V2 - REVISION to CD  
20-08, PH 3,4,5,7,10

**RE: The Point (South) – CD Package 2  
Case Number: CD 20-08  
Response to 1<sup>st</sup> Submittal Review Comments  
AWH20000**

Sheet C5.00

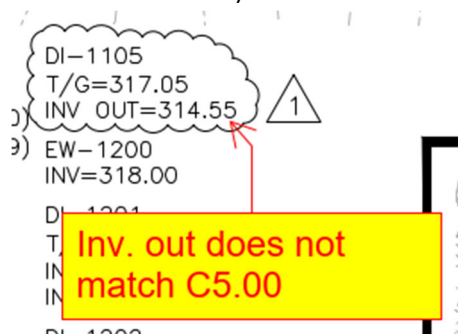
2. See PDF of mark-ups on the Plan set – there appear to be 2 comments.

3-1018) I/G=317.05  
INV OUT=314.40

3-102  
3-101

Inv. out does not  
match C3.15. Storm  
drainage report  
shows 314.55

**McAdams Response: The invert out elevation has been updated to 314.55 on sheet C5.00.**
